INNER WEST	
DEVELOPMENT ASSESSMENT REPORT	
Application No.	MOD/2020/0296
Address	18 Ferdinand Street Birchgrove NSW 2041
Proposal	Section 4.55(1a) modification of consent D/2019/242 to modify approved alterations and additions - internal and external changes to envelope and footprint of building.
Date of Lodgement	11 September 2020
Applicant	Mr Ray Stevens C/- Oikos Architects
Owner	Mr N A Hume and Ms L Le
Number of Submissions	Nil
Value of works	\$290,000.00
Reason for determination at Planning Panel	Clause 4.6 variation exceeds 10%
Main Issues	FSR exceeds 1:1 Site coverage breach Landscape breach
Recommendation	Approval with Conditions
Attachment A	Recommended conditions of consent
Attachment B	Plans of proposed development
LOCALITY MAP	
Subject Site	
Notified Area	
Objectors	
Supporters

This report is an assessment of the application submitted to Council for modification to determination No. D/2019/242 that approved alterations and additions to a dwelling house. The proposal seeks to modify the consent in the following way:

1 PLAN - GROUND FLOOR
 Scale 1:100

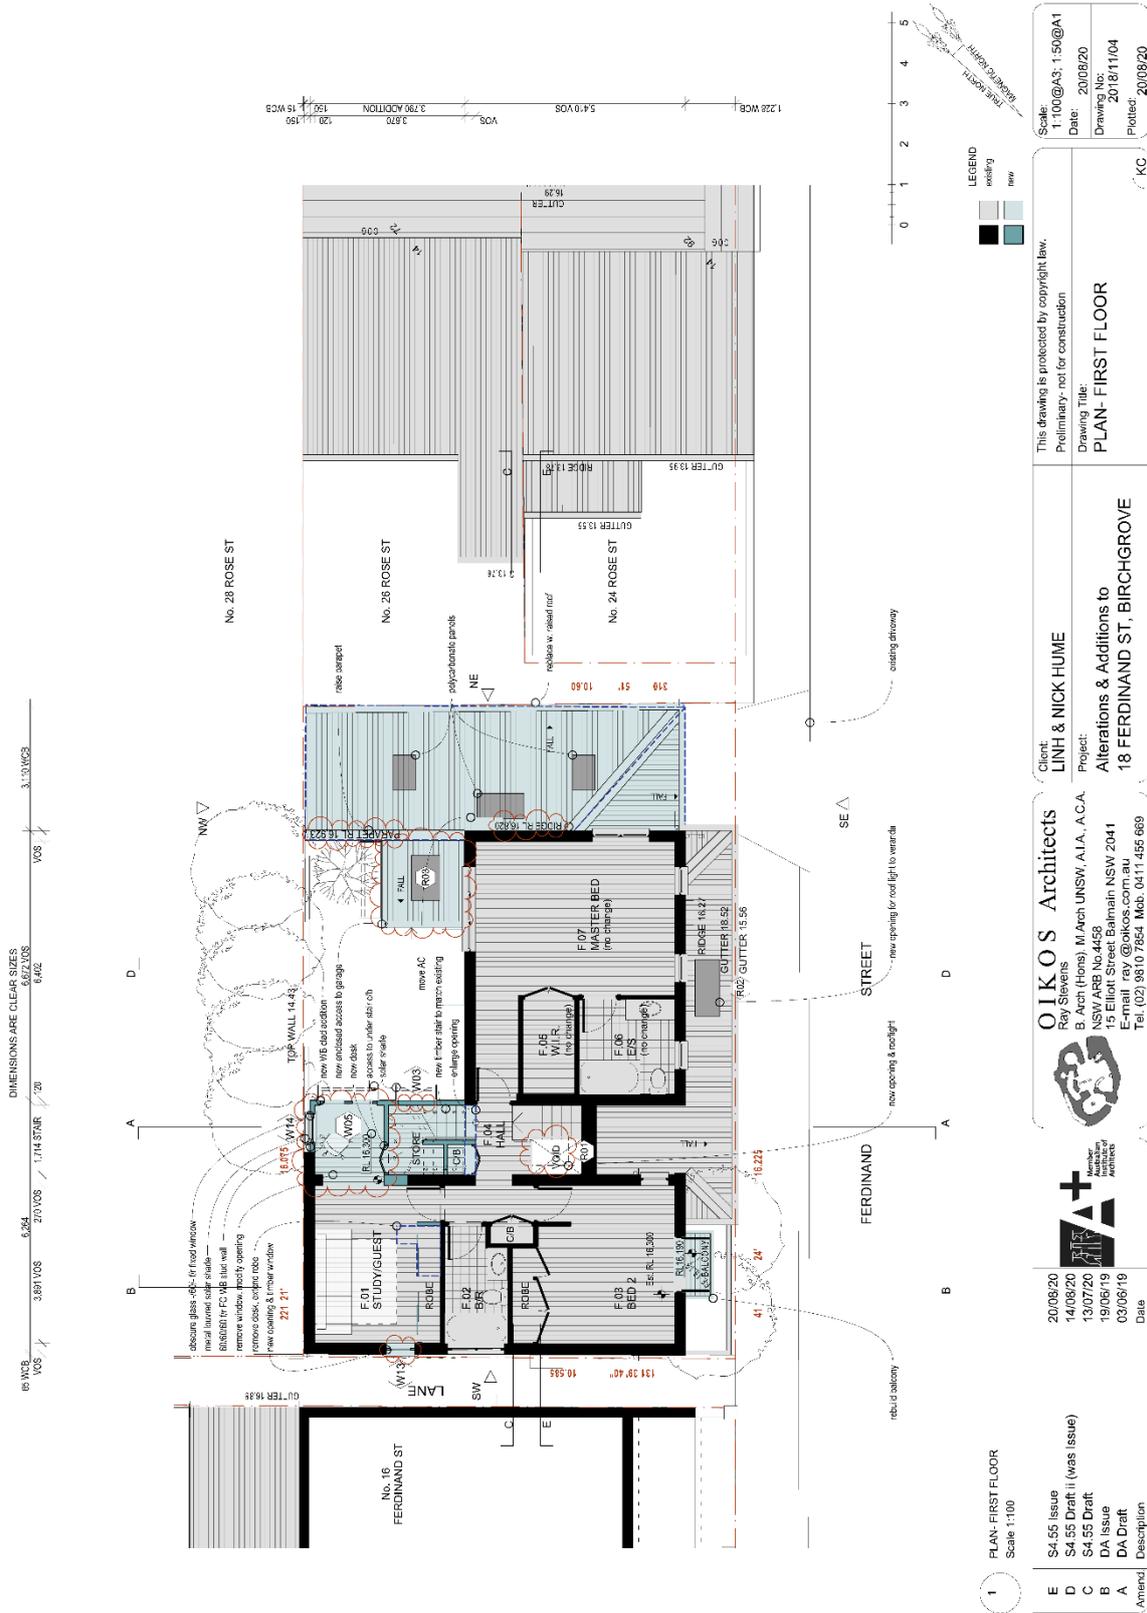
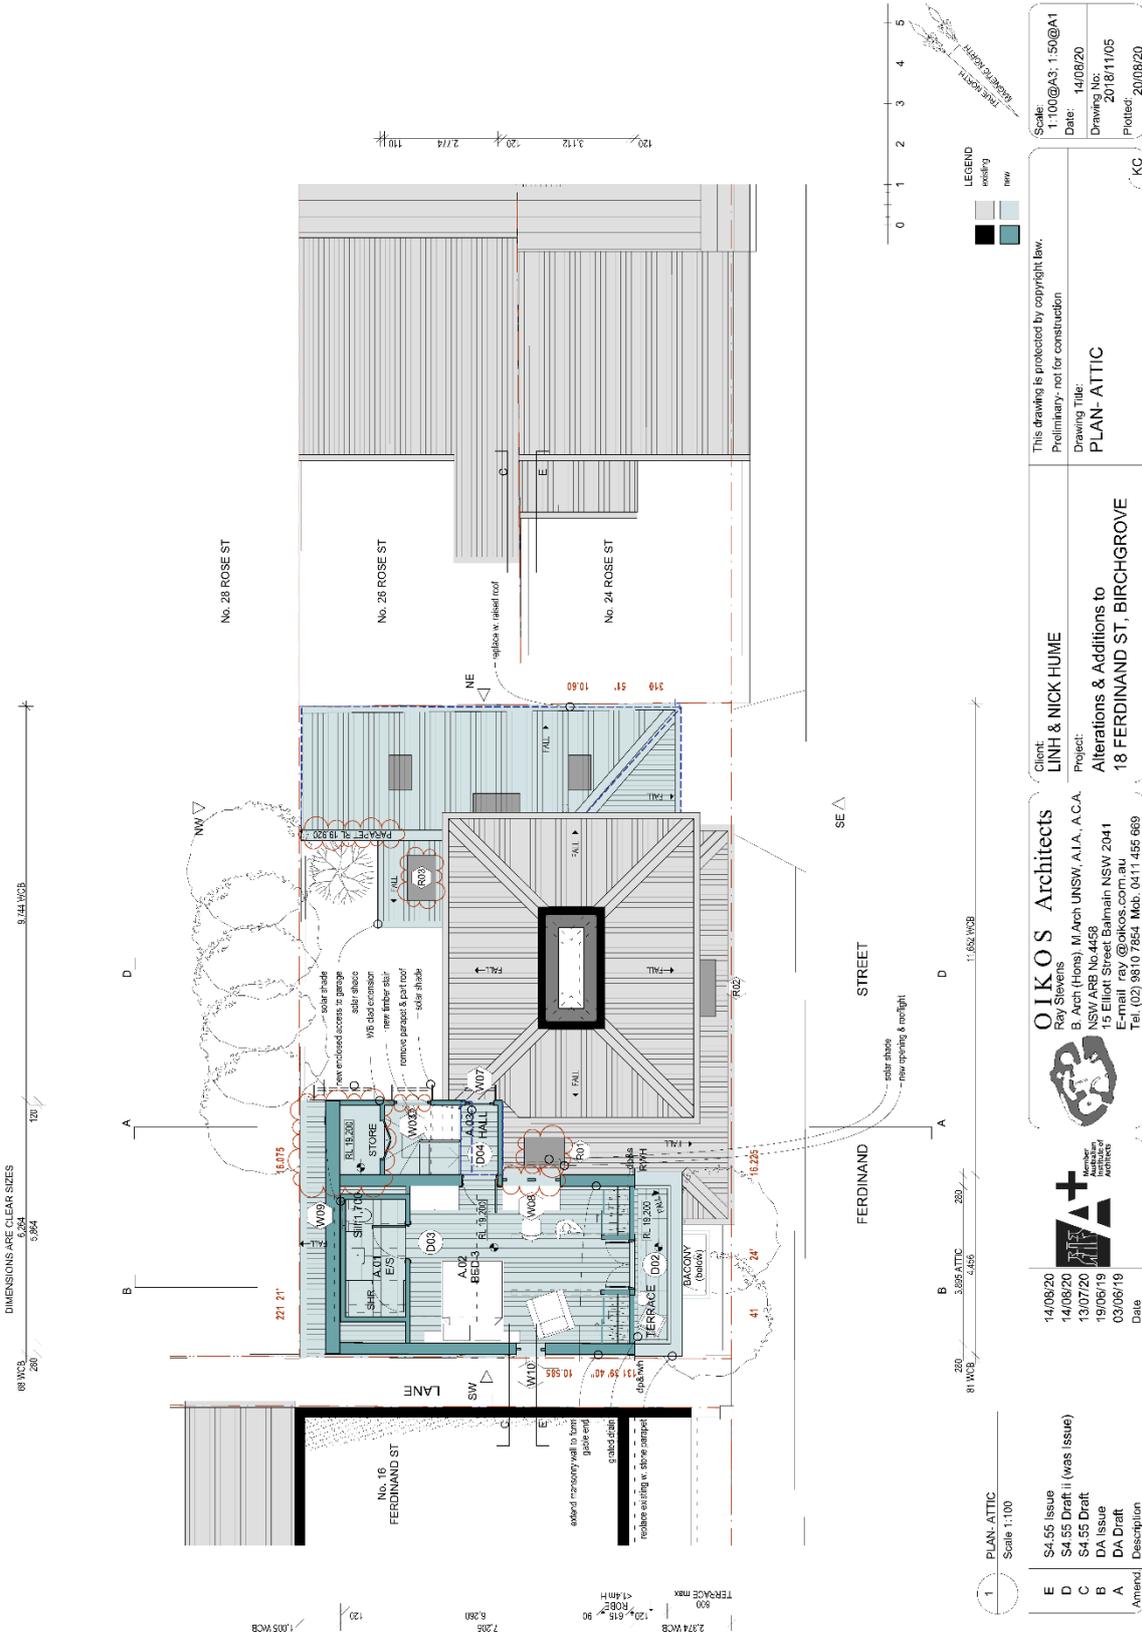
- Demolish brick nib walls and relocate window out toward the courtyard approximately 450mm.
- Form an enclosed link from the garage into the house.
- Modify the verandah to allow a bin store with access on the driveway side.

The infill under the stair for the purpose of a study and store causes negligible external impact and is acceptable. The increased floor space to house the internal link from the dwelling to the garage is also acceptable. Although the gross floor area and site coverage is increased in this instance, it is acceptable. The relocation of the garage to the boundary and increased head height by relocating the roof ridge will not detract from the street presentation of the approved design as it still reads as single storey. The rear roof plane design of the rear attic dormer is acceptable. All other internal reconfigurations and window changes are also acceptable.

This drawing is protected by copyright law.
 Preliminary - not for construction
 Drawing Title: **PLAN-ATTIC**

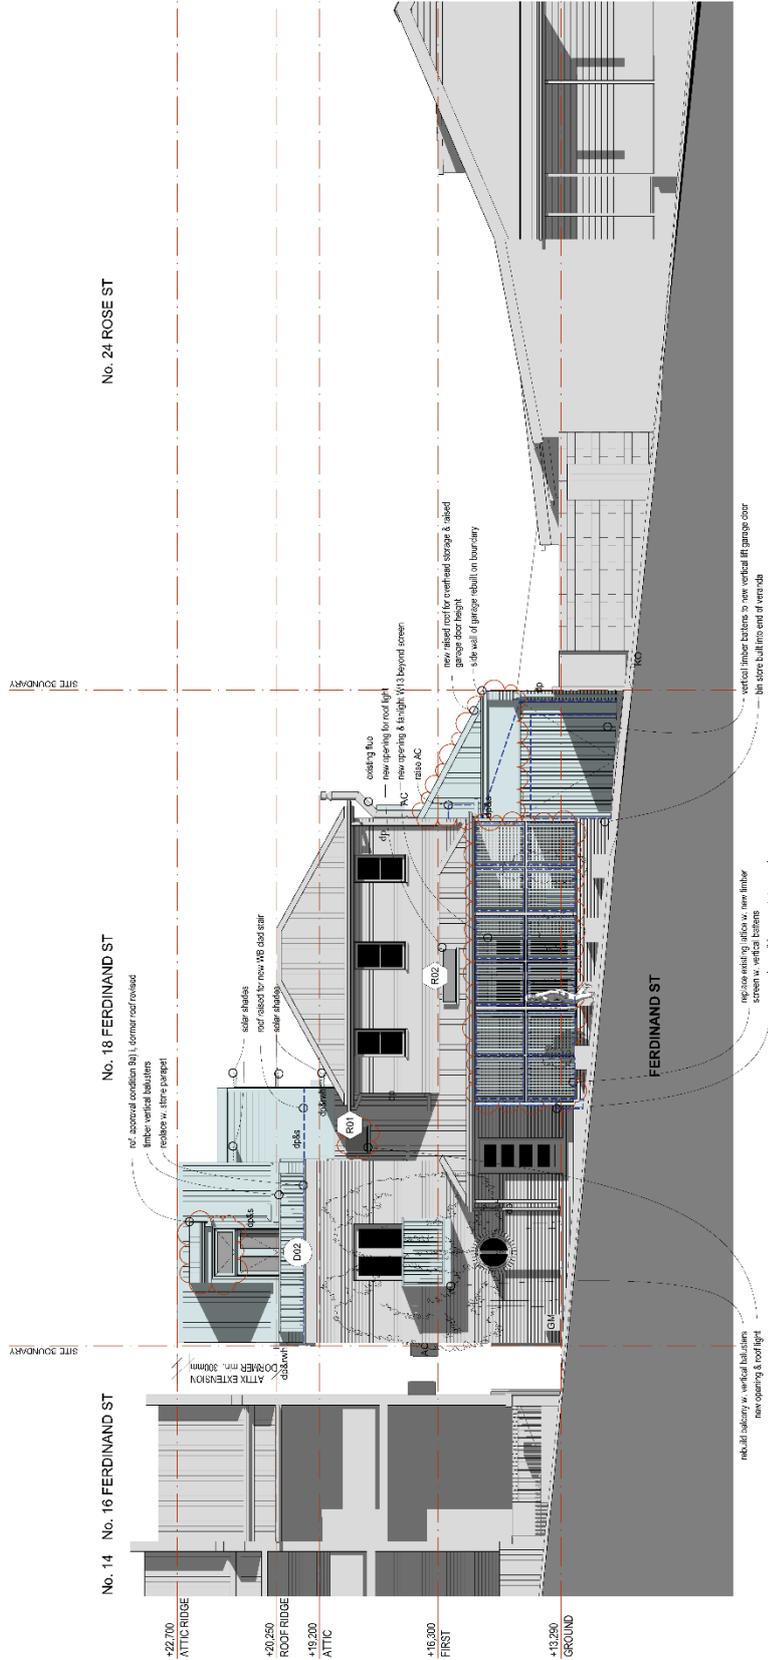
- Amended dormer to delete the curved head as per DA condition 9(a)(i). New store cupboard off the stair winders (over the extended study area below) Increase size of window W08 to take advantage of the view toward the NE.
- Increase size of window W03 on stair for additional light

The proposal has deleted the round headed termination of the dormer as per conditions and it is considered that the skillion termination is acceptable.

1 ELEVATION - SOUTHEAST (Ferdinand St)
 Scale 1:100

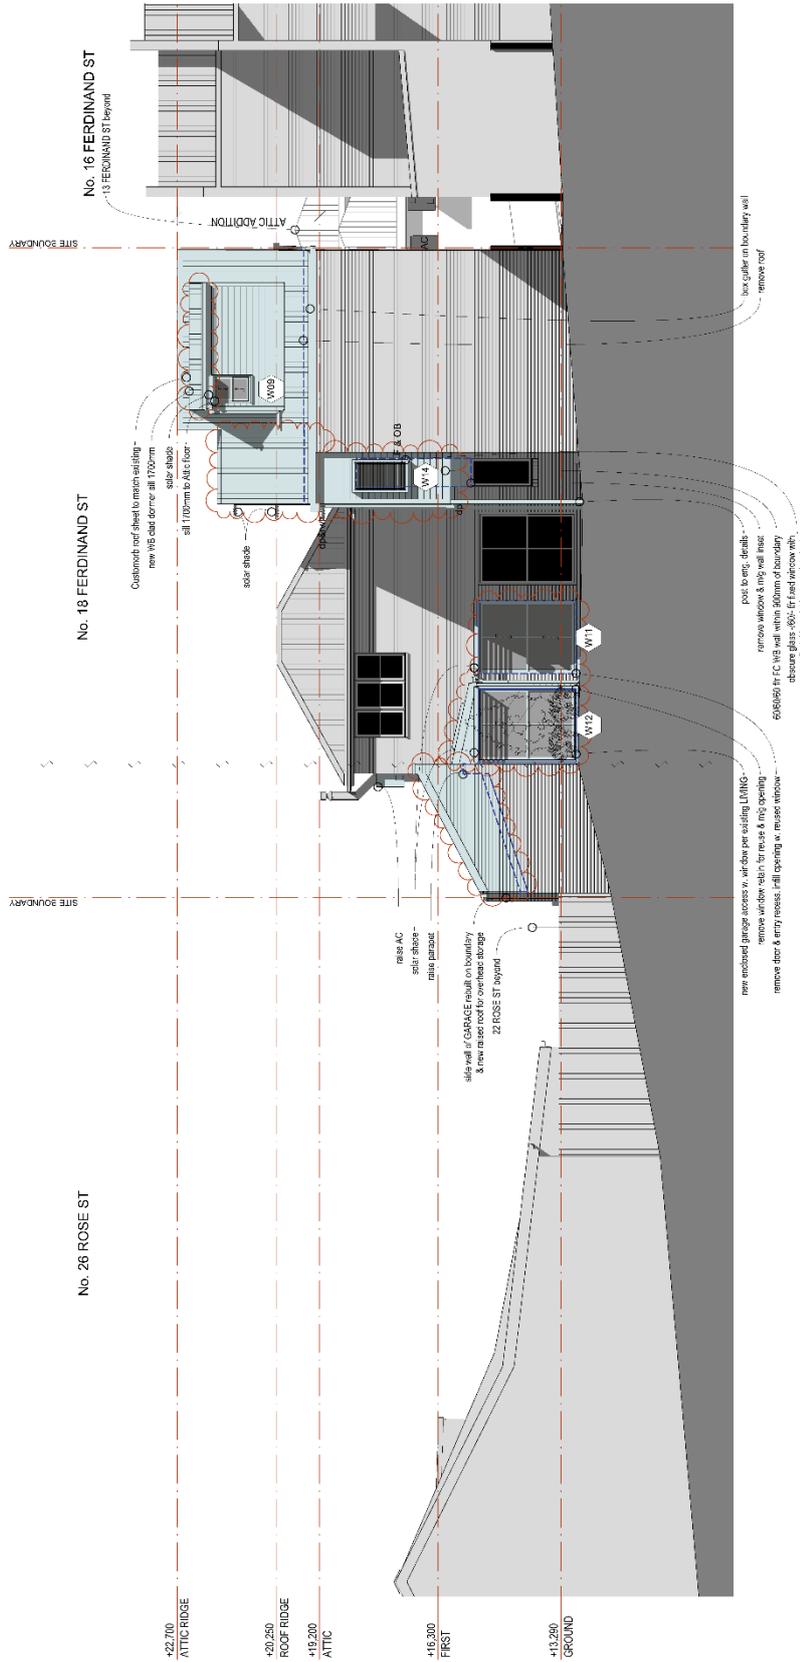
The proposed timber to the Ferdinand street veranda elevation is supported on streetscape grounds.

The development being modified is substantially the same development as the development for which consent was originally granted. Design changes are recommended on any consent issued to address the outstanding streetscape presentation and visual bulk concerns at the Ferdinand Street elevation. No authorities or bodies were required to be consulted. The application was notified in accordance with the regulations and Council's notification policy, and no submissions were received.
